Project:	2022-RFT-030 821131– Solid Waste Landfill Construction		
Addendum No.	02	No. of Pages:	8
Date:	2022-05-13	Doc. No.:	P7201-1591092266-153(1.0)

The purpose of this Addendum is to clarify and answer for bidder's question on tender 2022-RFT-030 issued for bid on April 19, 2022

Item 1B

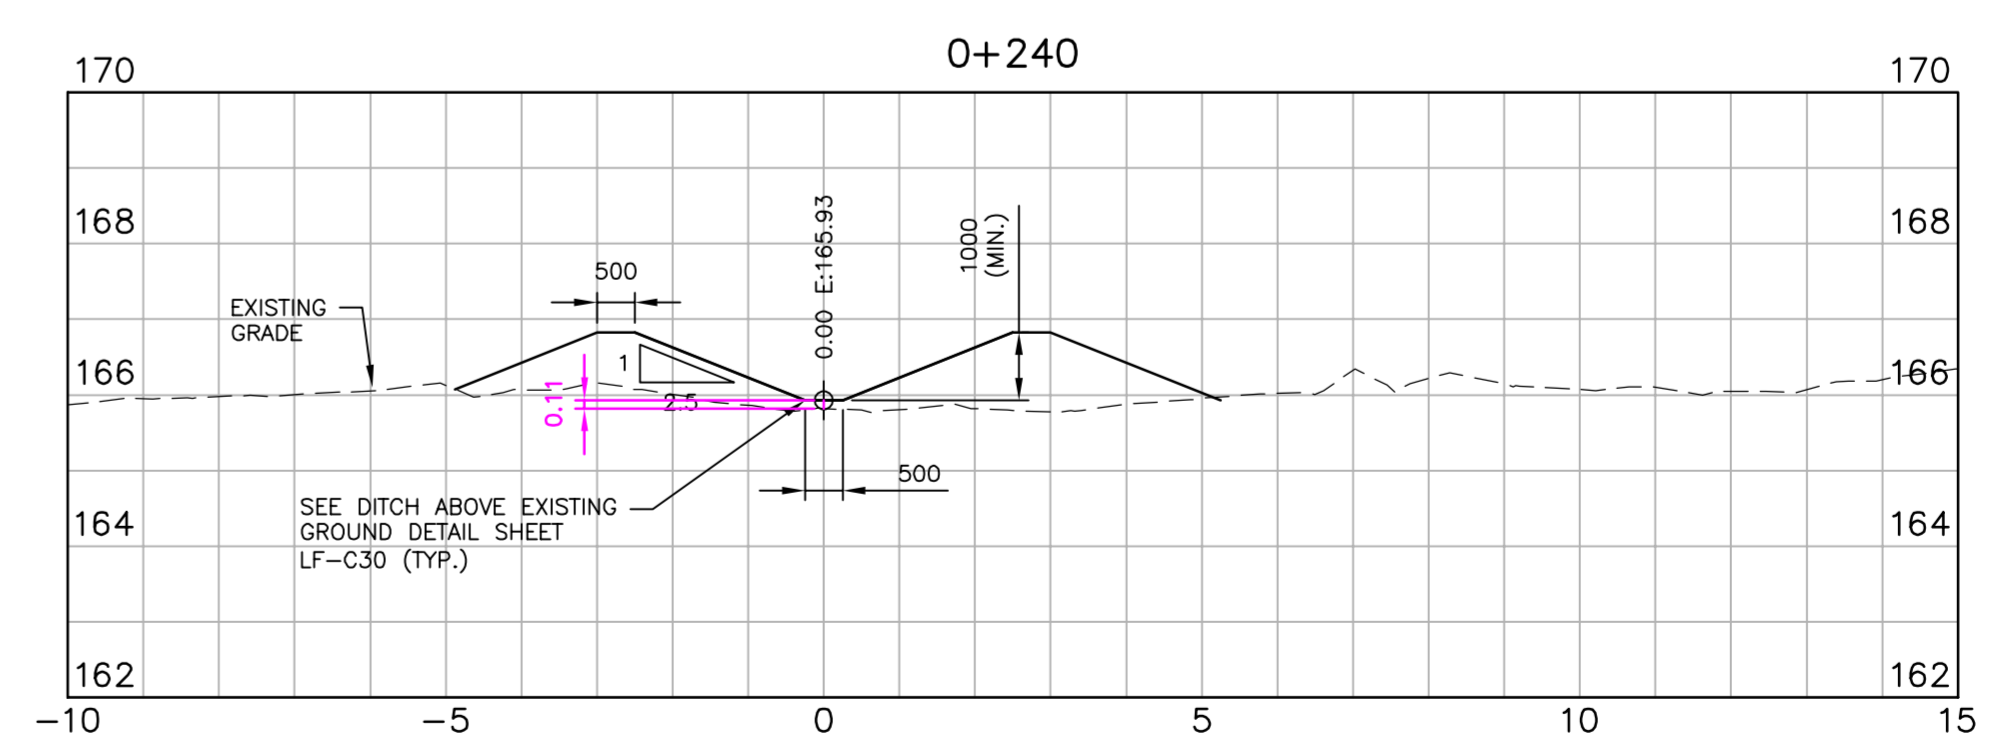
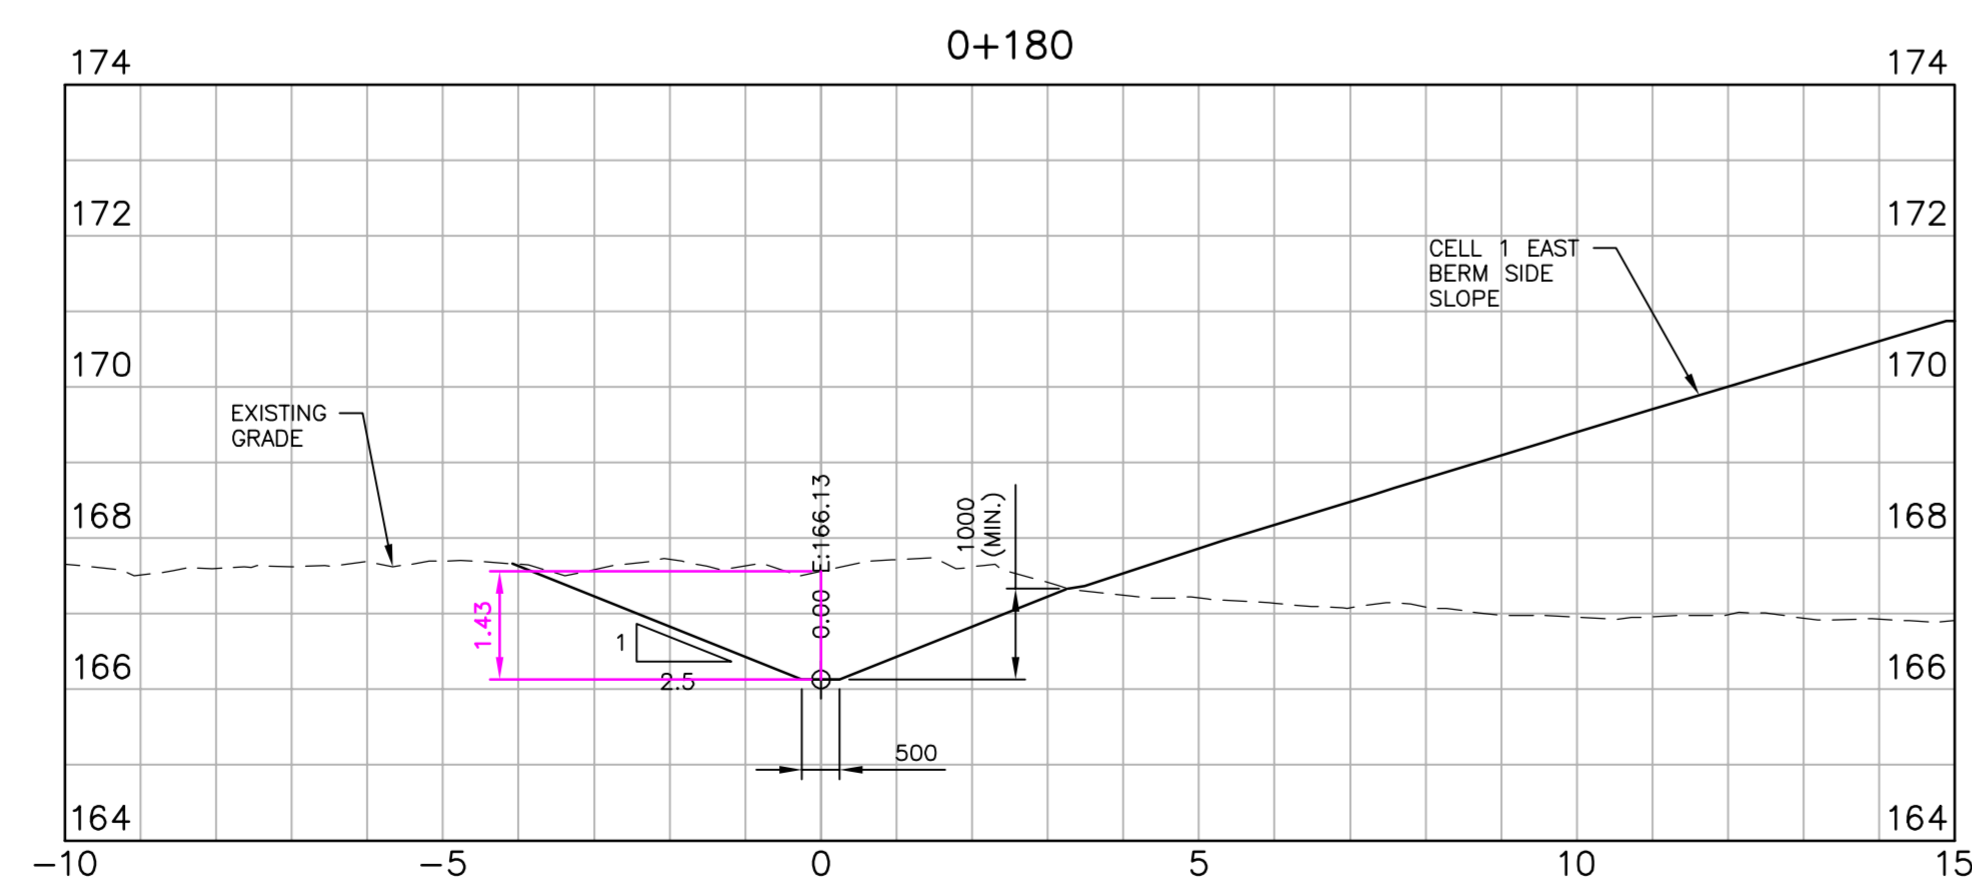
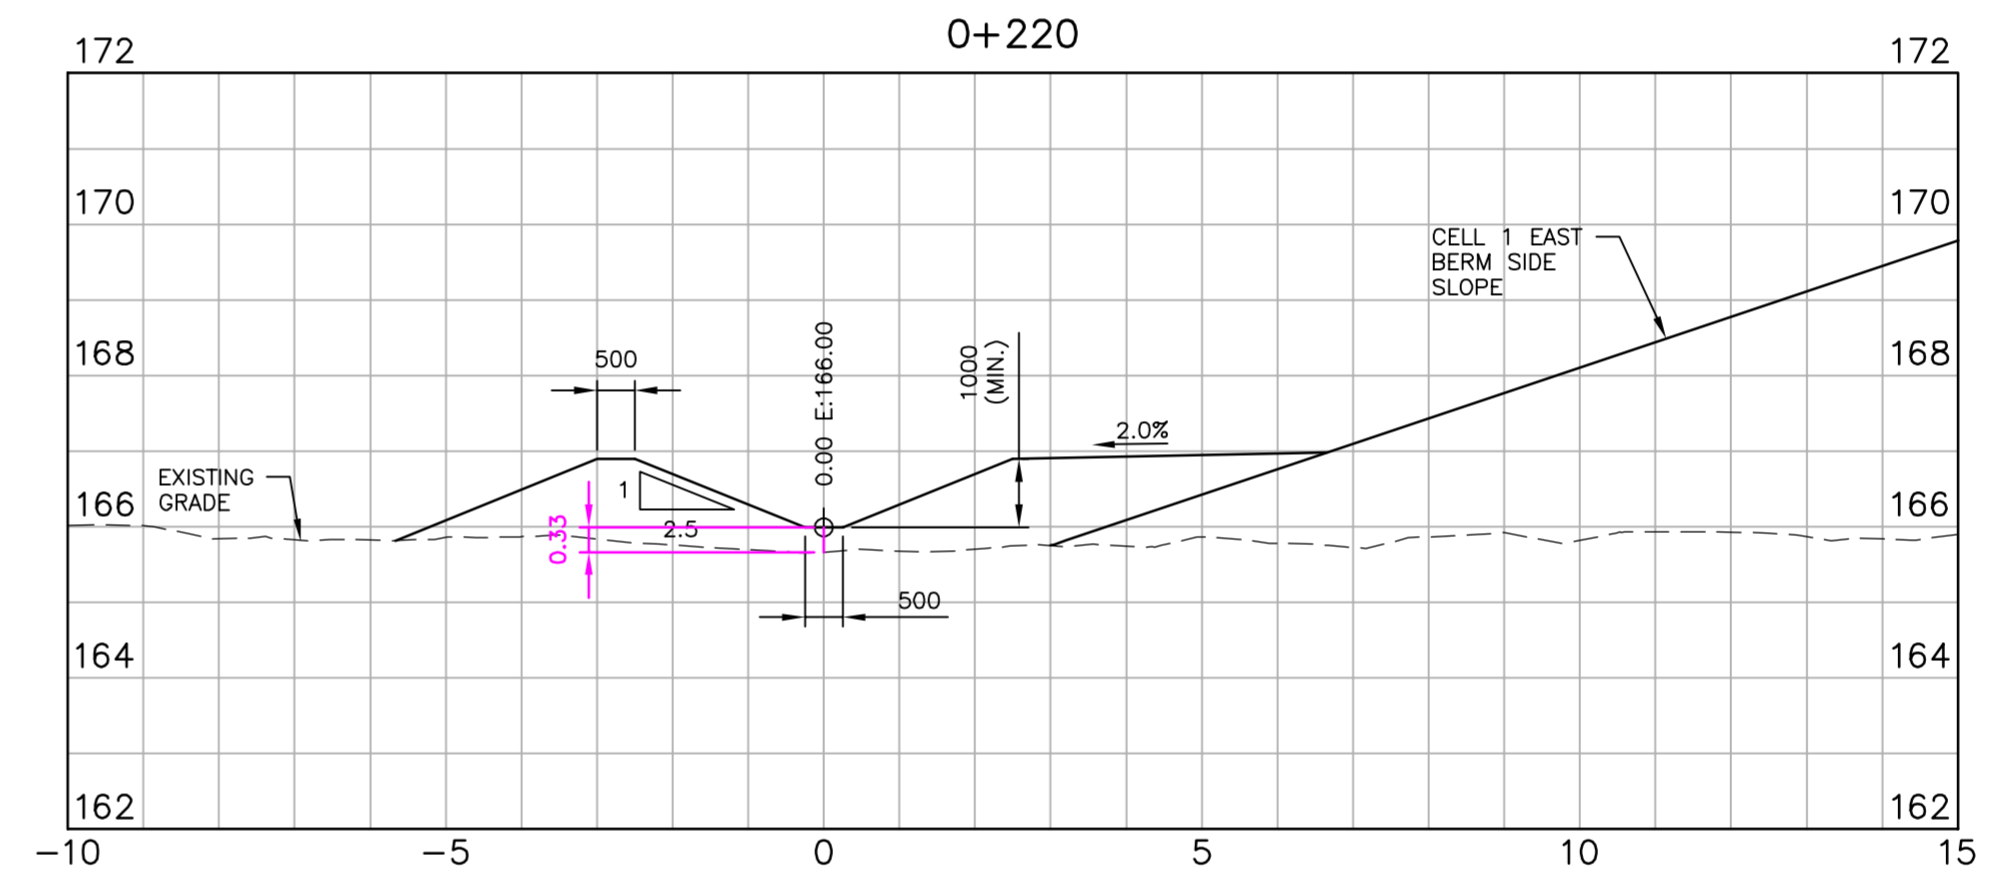
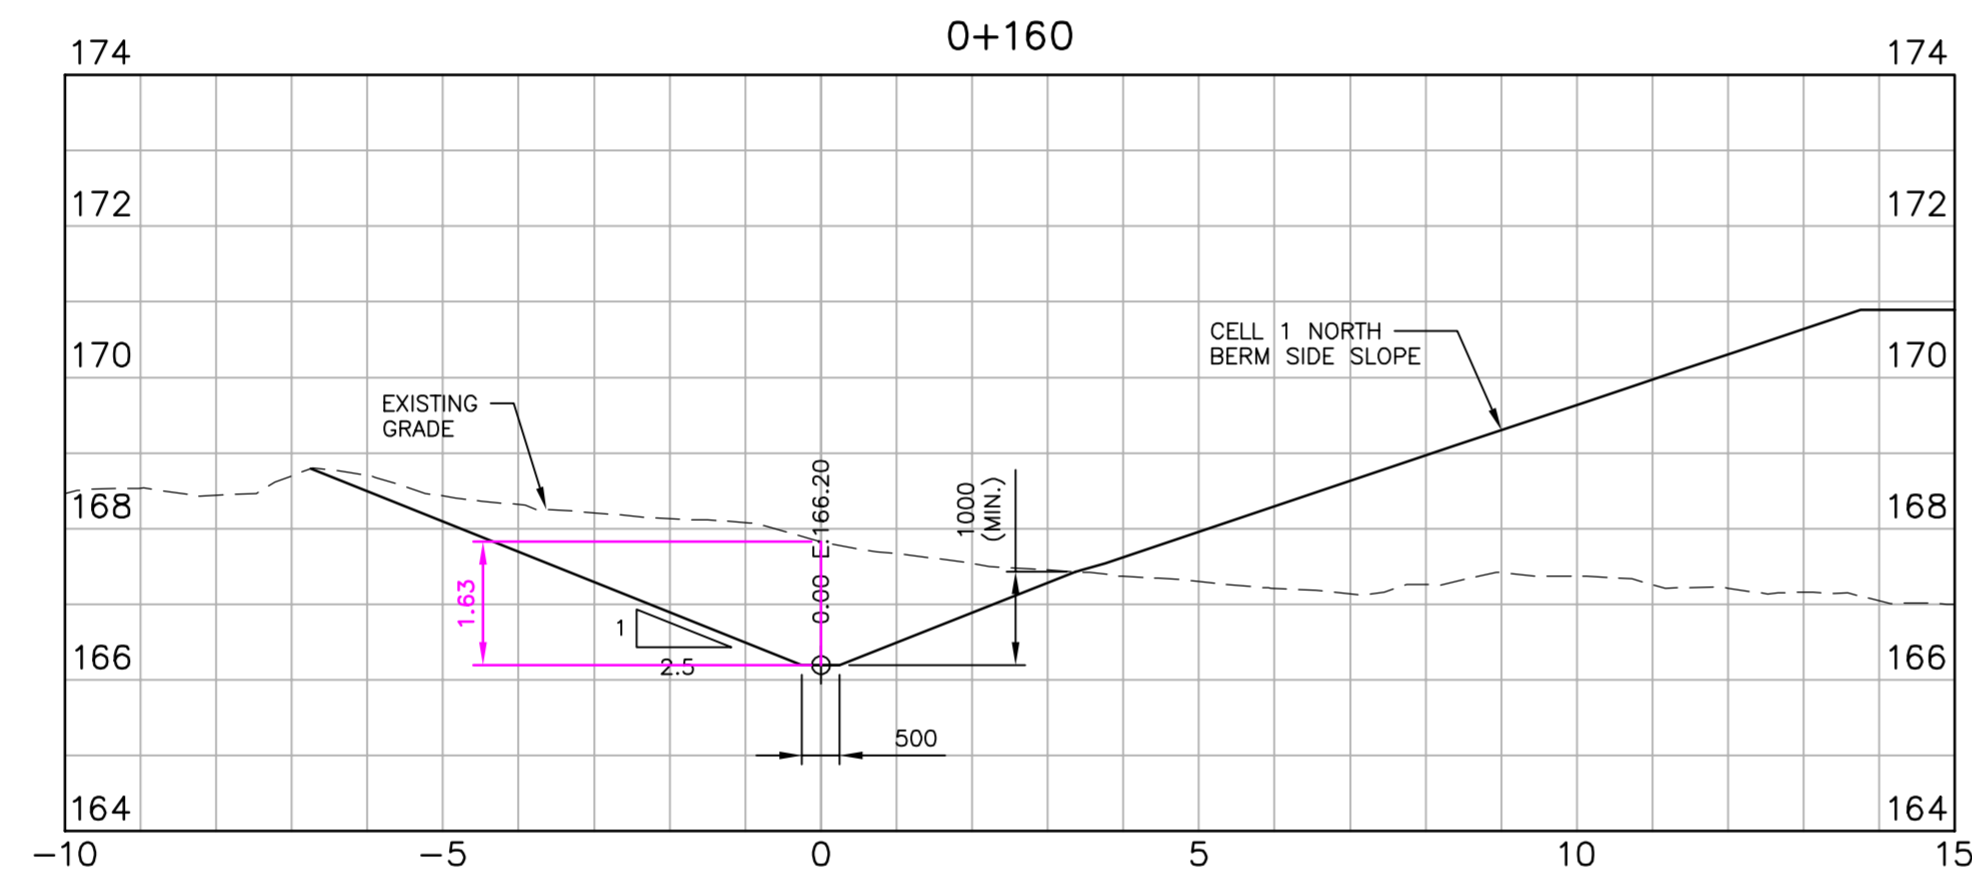
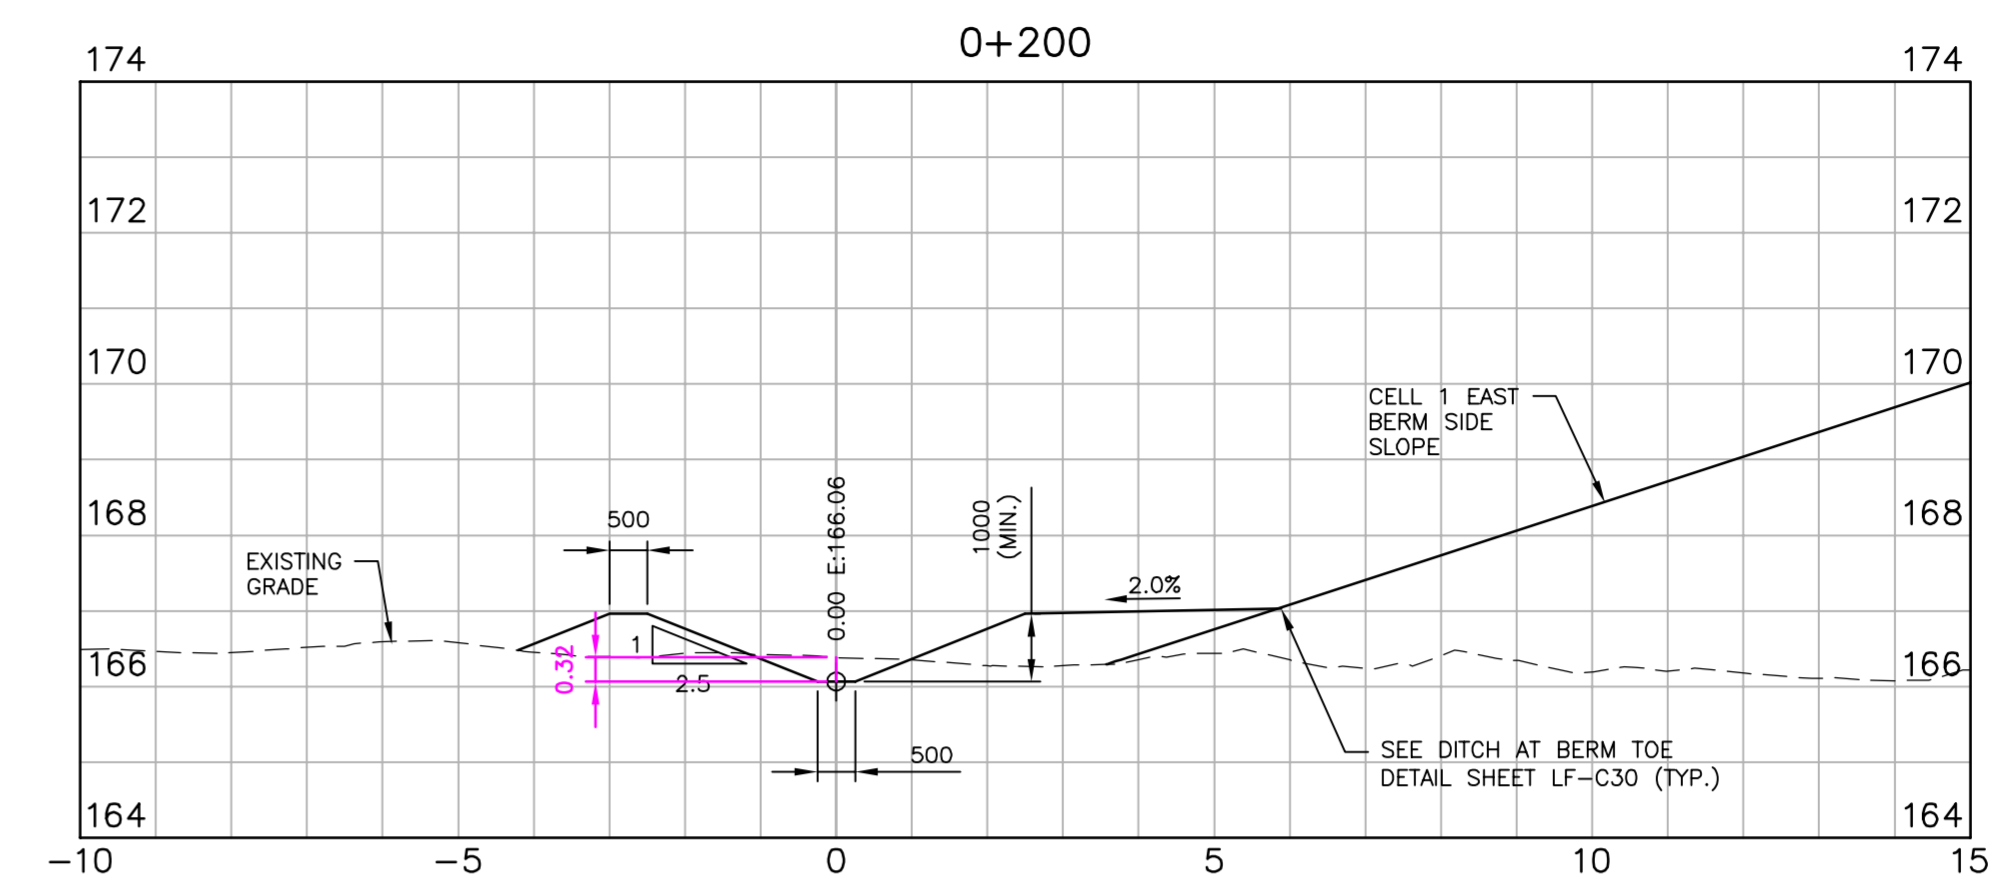
Please confirm limits of liner and geotextile for ditch as width is not clear ([Cell 1 Ditch Liner and Geotextile RFI.pdf](#))

Please see attached Item 1A and 1B.
